Fujitsu M10/SPARC M10 Systems

Product Notes for XCP Version 2044

Manual Code: C120-E702-03EN
April 2014

Figure 8-2 Shape and tab of crossbar cable (optical)

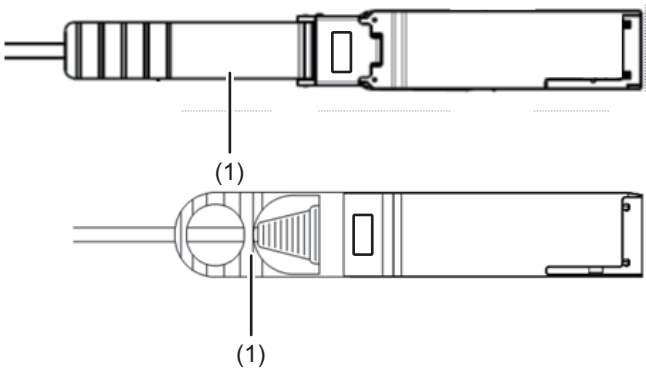
Section number or name	Contents of revision
4.3.1	Steps 2 and 3 described in "4.3.1 Changing crossbar cable (case in which the expansion rack 2 is added later)" will be changed. For details, see " Changing crossbar cable (case in which the expansion rack 2 is added later) ."

Note— There are two types of crossbar cables (optical). Connect cables of the same type to the same port number. Cables can be distinguished by tab shape. For tab shape, see Figure 8-2.

Figure 8-4 Connection of the link cables and management cable (SPARC M10-1 side)

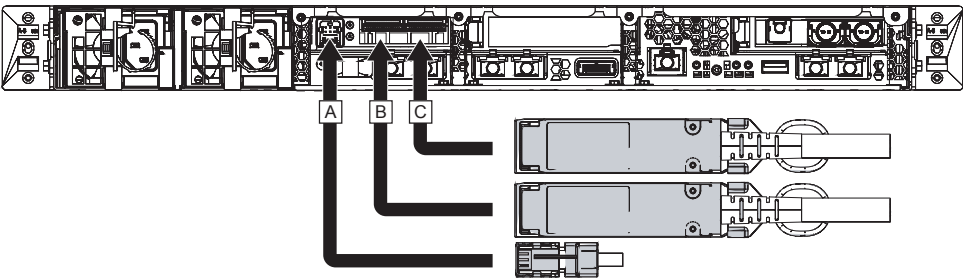
5.3	<p>Two notes in Step 2 in "5.3 Connecting Cable to PCI Expansion Unit" will be changed. Also, a figure showing the connection of the link cables and management cable (SPARC M10-1 side) will be added. For details, see "Connecting Cable to PCI Expansion Unit."</p>

Figure 8-5 Location of cable guide

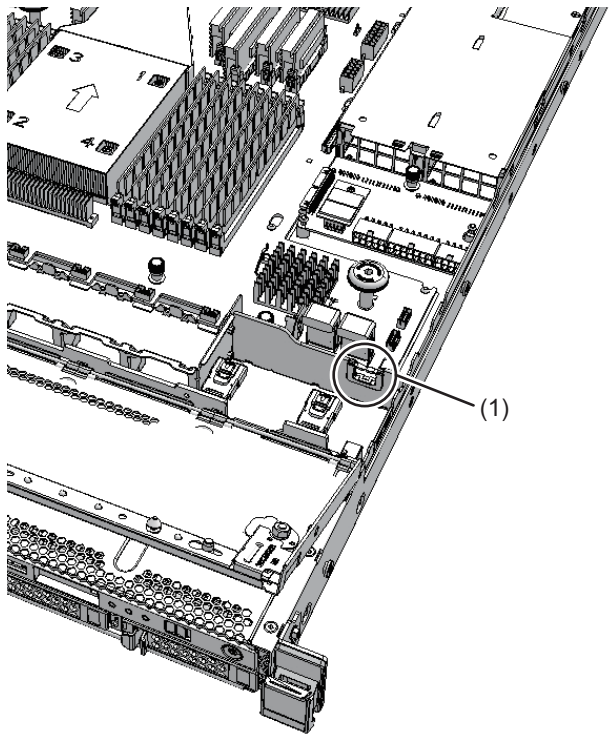
Section number or name	Contents of revision
7.5.1	Procedure to store cables in the cable guide will be added to Step 6 in "7.5.1 Installing motherboard unit." For details, see " Storing Cables in Cable Guide ."
13.4.2	Step 2 will be added in "13.4.2 Removing PSU backplane." For details, see " Removing PSU backplane ." The following procedures will be moved down:
13.5.1	Step 5 will be added in "13.5.1 Installing PSU backplane." The following procedures will be moved down: For details, see " Installing PSU backplane ."
Chapter 16	"Chapter 16 Maintaining Cable Kit" will be added. For details, see " Appendix A Maintaining SPARC M10-1 Cable Kit ."

6. Store cables of the motherboard unit in the cable guide.

Figure 8-11 Cable for the HDD backplane

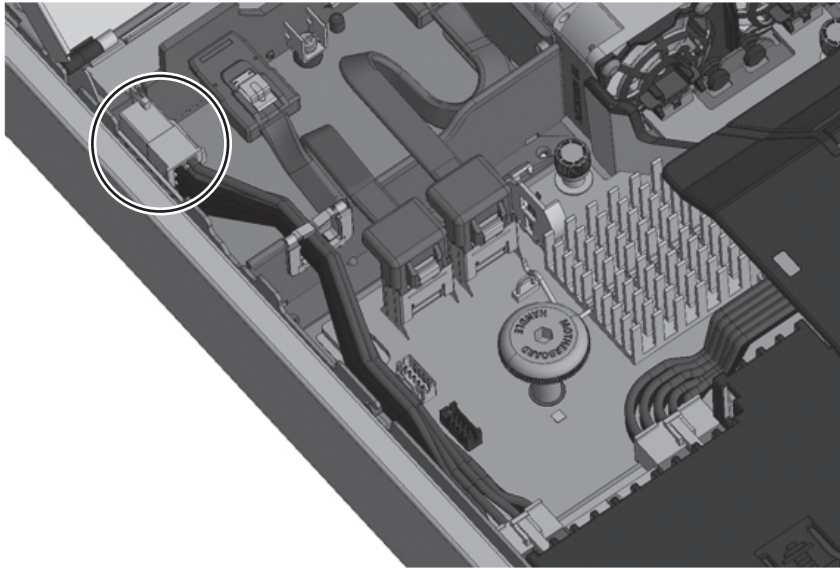
- 2. Remove one cable of the HDD backplane which connects the PSU backplane and the HDD backplane.**

Figure 8-12 Cable for the HDD backplane

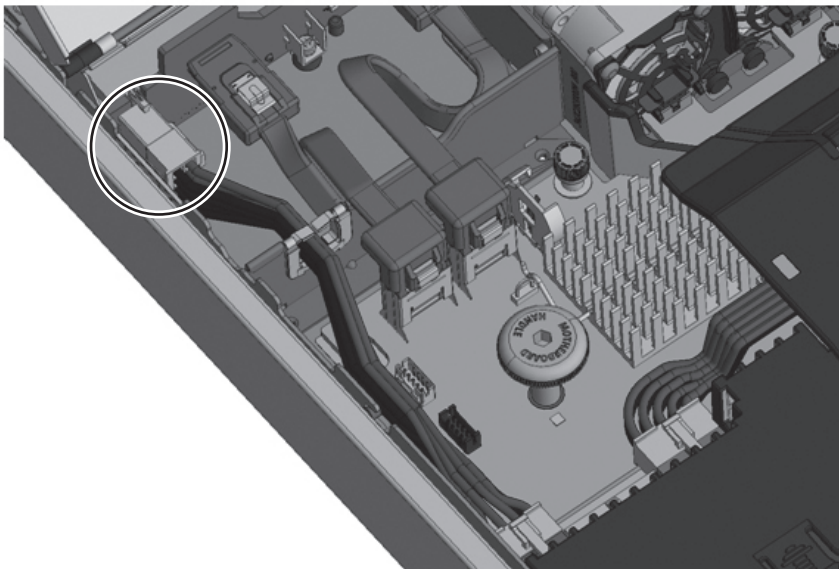
5. **Connect one cable connecting the PSU backplane with the HDD backplane.**
